**ERRATA SHEET FOR**
ANSI/ASHRAE STANDARD 93-2010 (RA 2014)
Methods of Testing to Determine the
Thermal Performance of Solar Collectors

March 18, 2014

Figure 4 Testing configuration for solar collectors where heat transfer fluid is air.

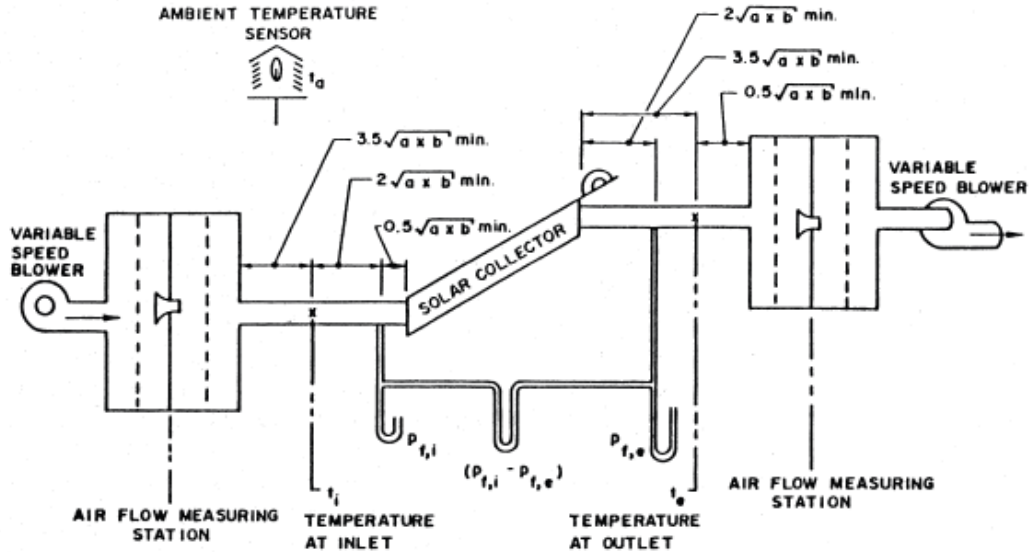
9   **Figure 4 Testing configuration for solar collectors where heat transfer fluid is air.** Identify the variables a and b in Figure 4 as shown below.
       (Note: Additions are shown in underline)

where
a = the height of the air collector air flow opening
b = the width of the air collector air flow opening
(Not to be confused with these letters used as subscripts.)
